## Multi-signatory public comment response

Re: Project File #608020 Cape Cod Bridges Project

However, the current design for the multi-modal facility on the Bourne South Quadrant presents significant safety and usage issues. Happily there is a straightforward opportunity for improvement: Replace the planned long, graded descent with a light-use overpass over the canal access road. As our public comment, we're highlighting the issues in more depth, and proposing a design modification.

Figure 2 - Location of proposed overpass versus existing path plan

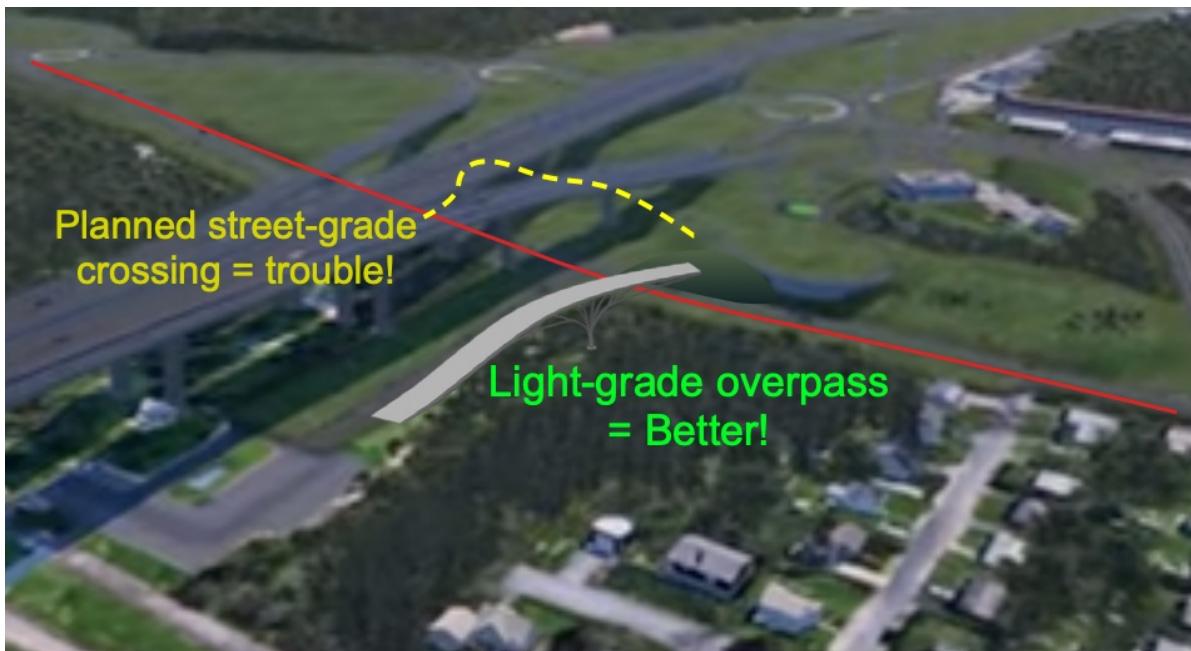
There is a simple, cost-effective alternative. Rather than constructing the path's long descent to road grade, the design could leverage the existing elevation and the now-planned retaining wall to create a light, ramped, grade-separated multimodal overpass, eliminating the issue entirely. Figure 2 illustrates this.

**The change can leverage planned-structures, and may be cost effective.** There is already 1 structural berm and major path descent grading planned; this can be reworked into the southerly approach to the proposed overpass. The northerly descent can be a light, multi-modal (not vehicular) grade structure. Some - most? - of the overpass cost can be covered by reallocation of the costs for the descent path and supporting structures required in the current design.<sup>1</sup>

**Figure 3 - Descent Ramp into existing public property**

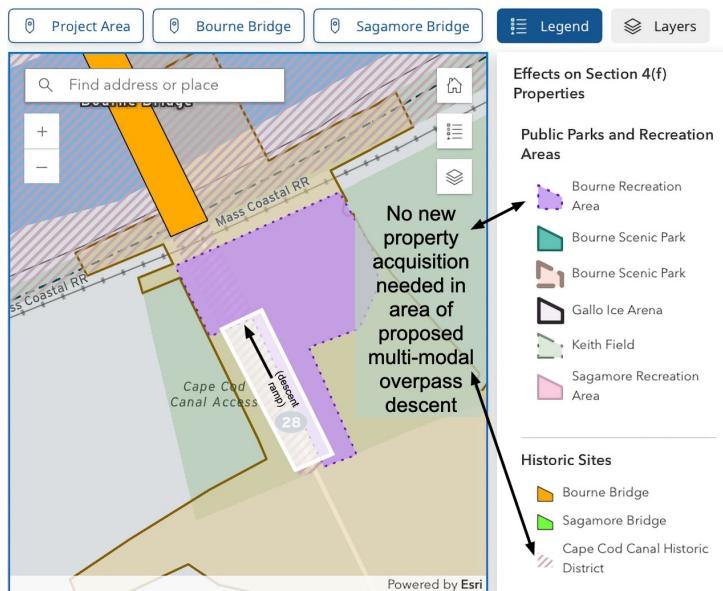
The northern side of the overpass, which constitutes the descent over grade, can descend into the existing Bourne Recreation Area and adjoining Cape Cod Canal District property; no property taking is required. See rough placement illustrated in Figures 3 & 4.
